Class II Permissive Change Letter

FCC ID: 2AMTQHA88XX

Subject: Request Class II Permissive Change for FCC ID: 2AMTQHA88XX

Original
Left
Antenna

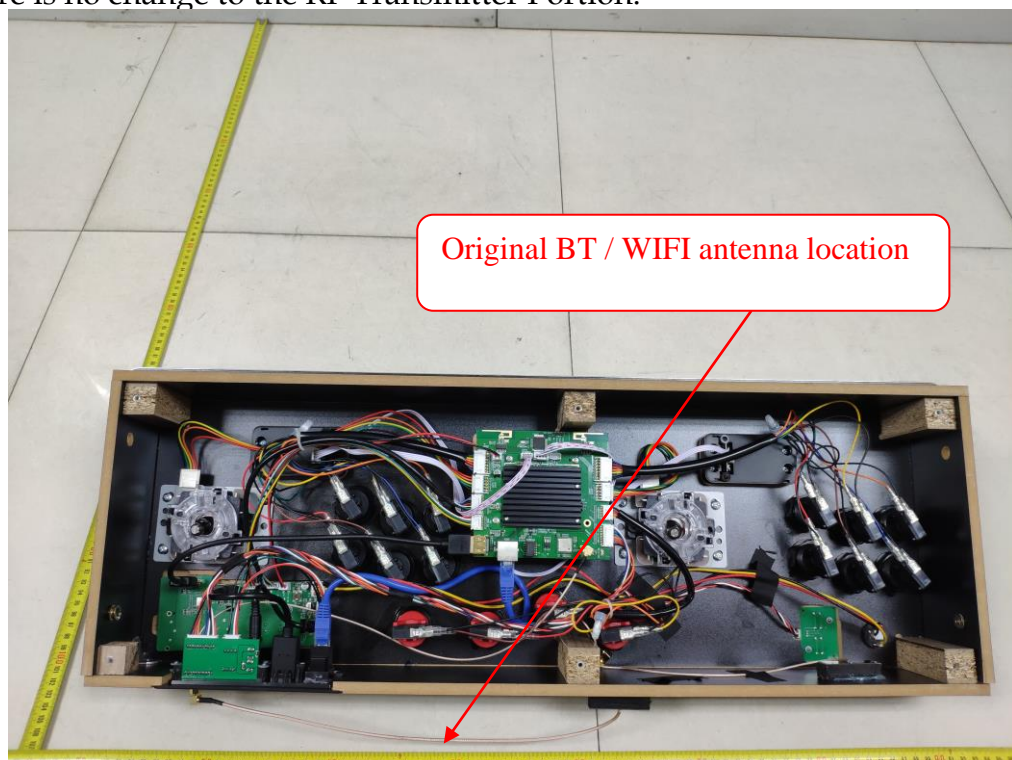
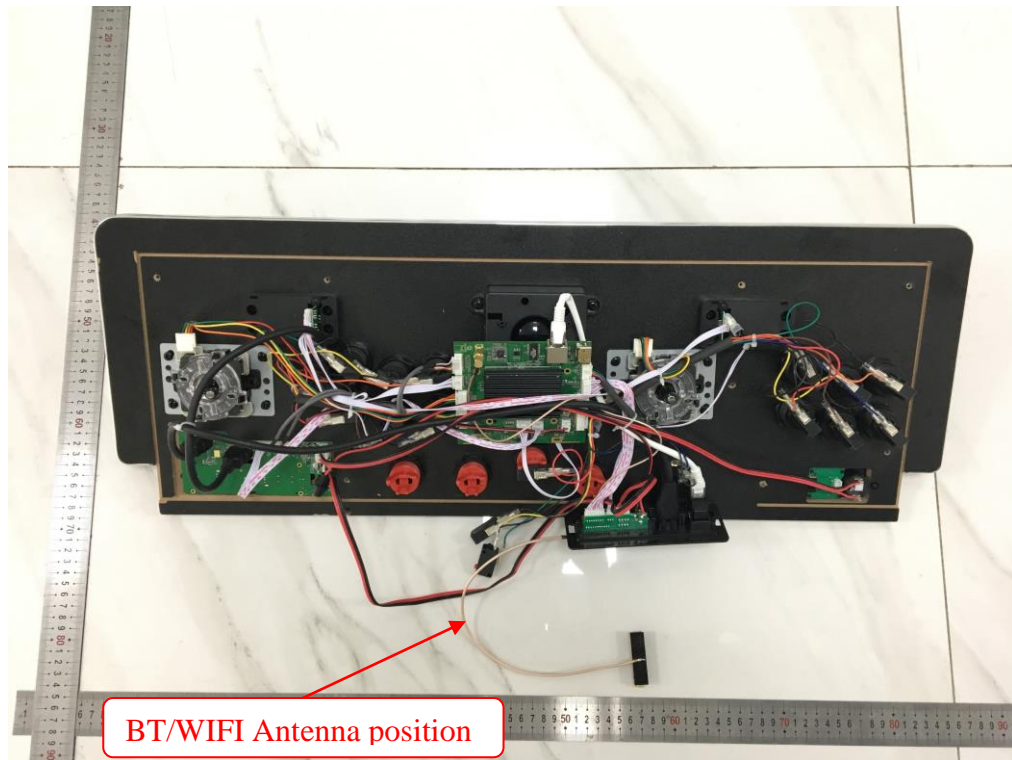
1. External photos not change;
2. This product has changed the PCB layout. The Bluetooth / WiFi antenna has been moved from the left side of the original PCB to the right side of the PCB. Please see the photos.
3. There is no change to the RF Transmitter Portion.

I attest that such change will not affect the RF function (the output power of new less than original grant) the RF function out of the grant conditions.
